UNITED STATES
NUCLEAR REGULATORY COMMISSION
WASHINGTON, D. C. 20555

LICENSEE: Florida Power Corporation
FACILITY: Crystal River Unit 3
SUBJECT: SUMMARY OF MARCH 30, 1988 MEETING ON
CRYSTAL RIVER UNIT 3 (CR-3) ON OSTI AND EFW ISSUES

On March 30, 1988, representatives of Florida Power Corporation (FPC) met with representatives of the NRC staff to discuss the matters summarized below. The list of attendees and slides presented during the meeting are enclosed.

EFP-1 BLOCK/TRIP

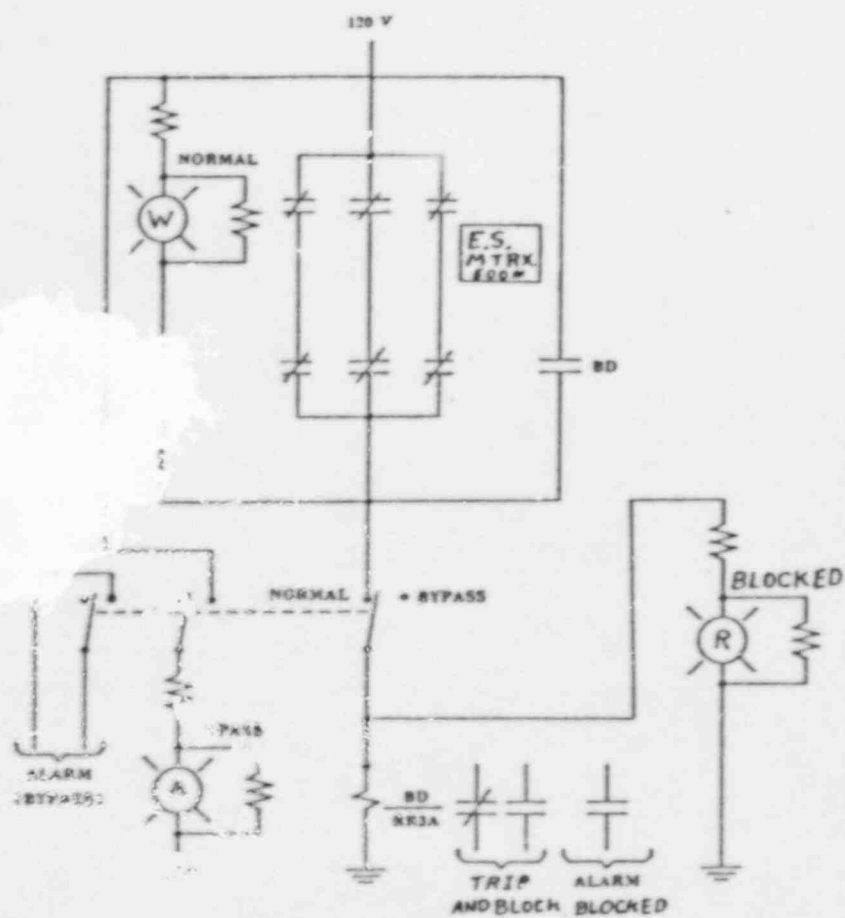
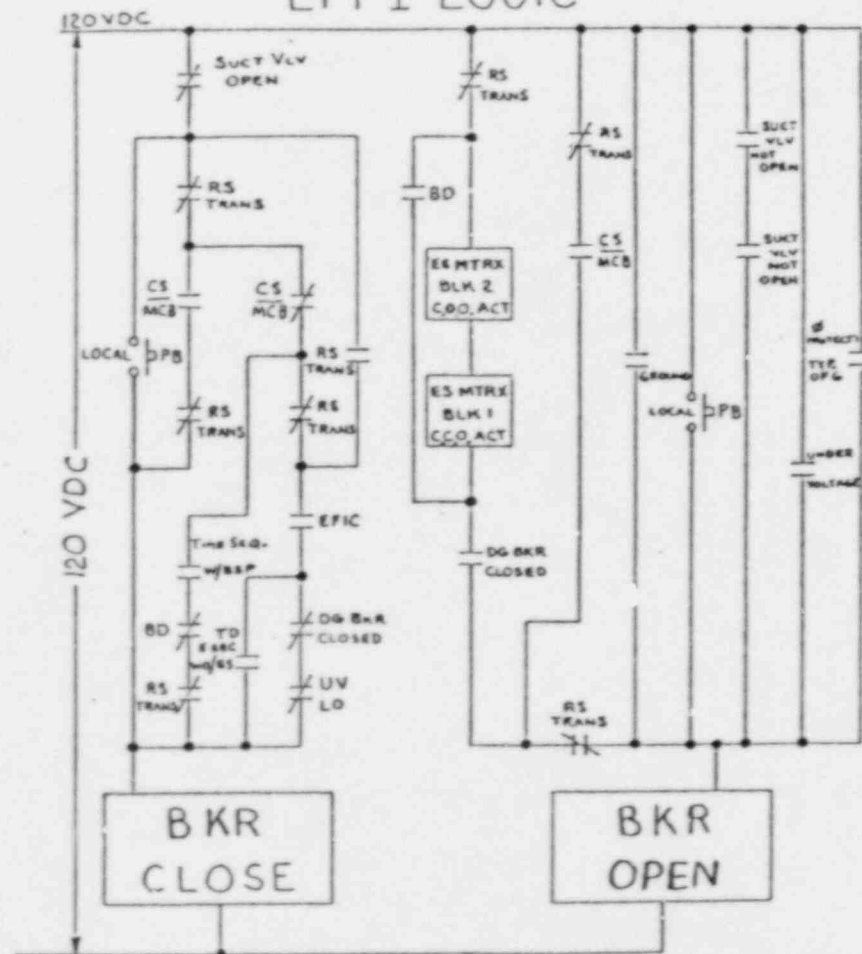
The licensee noted that with the present plant configuration the worst-case scenario EDG loading is approximately 3113 KW, but that no scenario requires both the emergency feedwater pump (EFW) pump and the decay heat (DH) pump at the same time. The proposed EFW pump block/trip circuitry, which would prevent such concurrent operation, was described. With this circuitry, the controlling scenario then becomes an intermediate Loss of Coolant Accident (LOCA) where reactor coolant system pressure does not drop below 500 psi, in which case the EFW pump is needed and the DH pump is not. The EDG load in this case is 2882.5 KW. Comments regarding the block/trip solution included:

- a. There is concern in removing the diverse low pressure injection (LPI) actuation signal (4 psi RB pressure). Can the 30 psi RB pressure signal be used instead?
- b. The question of long-term need for loads not needed immediately must be addressed.
- c. The possibility of additional risk or problems being introduced by the block/trip design in other perhaps more likely or more serious scenarios must be examined carefully. It must be assured that failures which could prevent operation of EFW or of decay heat removal are not made more likely.
- d. The battery charger and other loads as appropriate should be added back on the EDG.

The licensee noted that it intended to install the block/trip modification during the next refueling outage. The schedule for submittal of the design is before the fall of 1988, with earlier responses to the concerns raised above.
